MAIN POS | Front

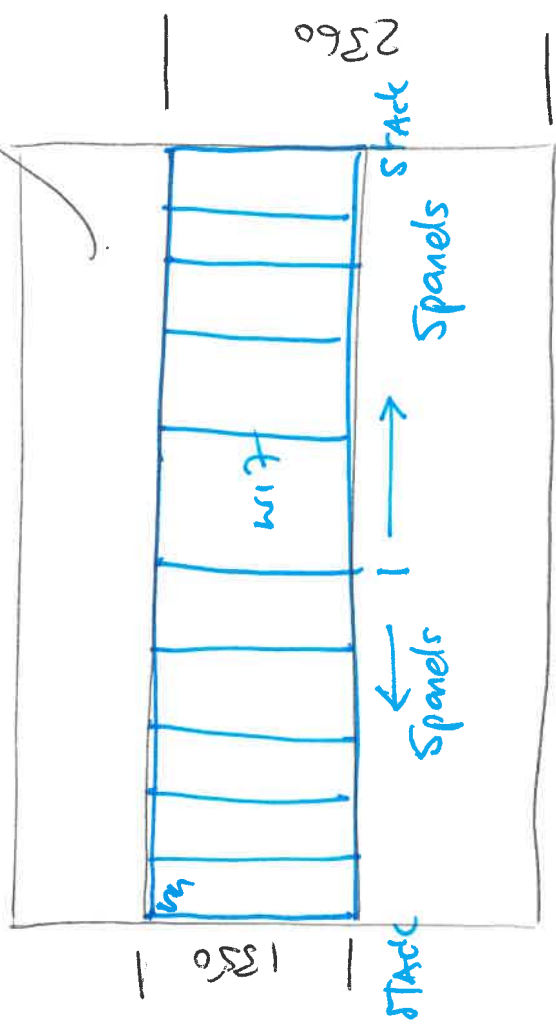
Remove Existing and add new

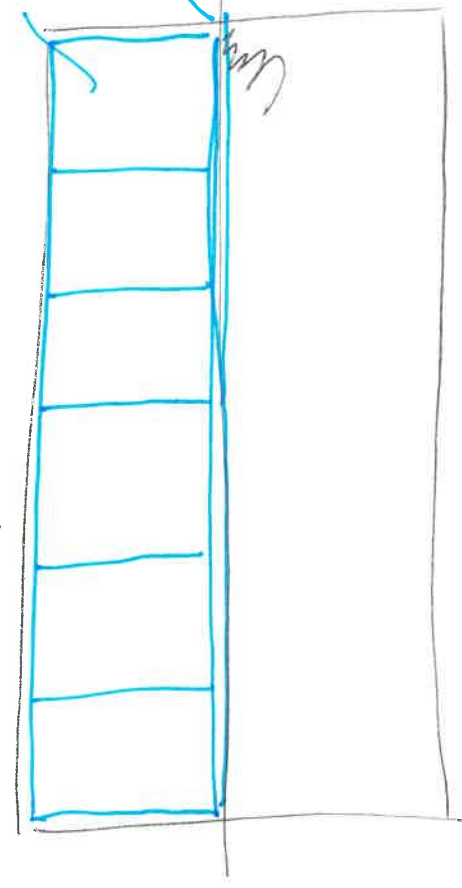
Beam required

w17 to BOTH ENDS
